PLANNING, ZONING, & BUILDING DEPARTMENT
PZ&B Staff Memorandum: Town Council Development Review

SUBJECT: ZON-22-078 (ARC-22-123) 231 BRADLEY PL (COMBO)

MEETING: OCTOBER 12, 2022

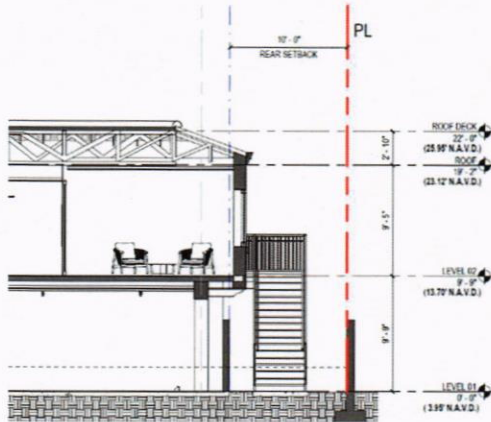
- Section 134-226 and 134-227 Special exception and site plan review approval to permit the owner-occupied single user use as an office for a financial advisor and the addition of a 264 SF terrace on the second floor.
- VARIANCE 1: Sec. 134-1113 (7): A variance to reduce the required rear (east) yard setback of 10' to 3'-7" to accommodate a new exterior stair.
- VARIANCE 2: Sec. 134-1113 (7): A variance to permit the addition of a 264 SF second story terrace with a (north) side yard setback of 1' in lieu of 5' required.

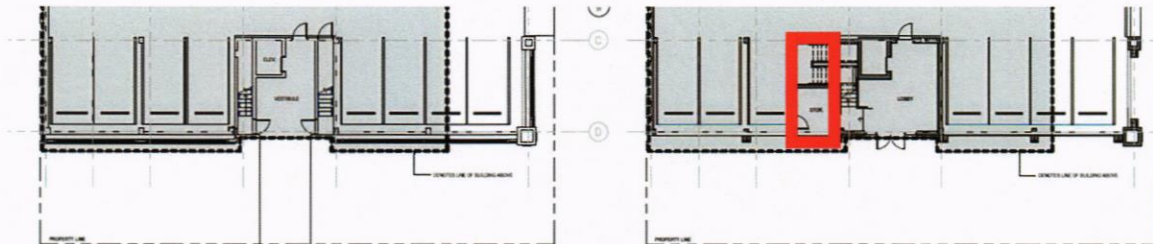
As it pertains Variance 2, to reduce the required 5' side setback by 4' in order to construct the addition of an outdoor elevated 264 second story terrace at 1' setback to the north side setback. The existing building already contains a nonconforming side setback of 1' and the applicant seeks to align the terrace with the exterior wall. The reduced setback is likely not to impact the abutting one-story office building but may impact the privacy of the abutting one-story residence also to the north.
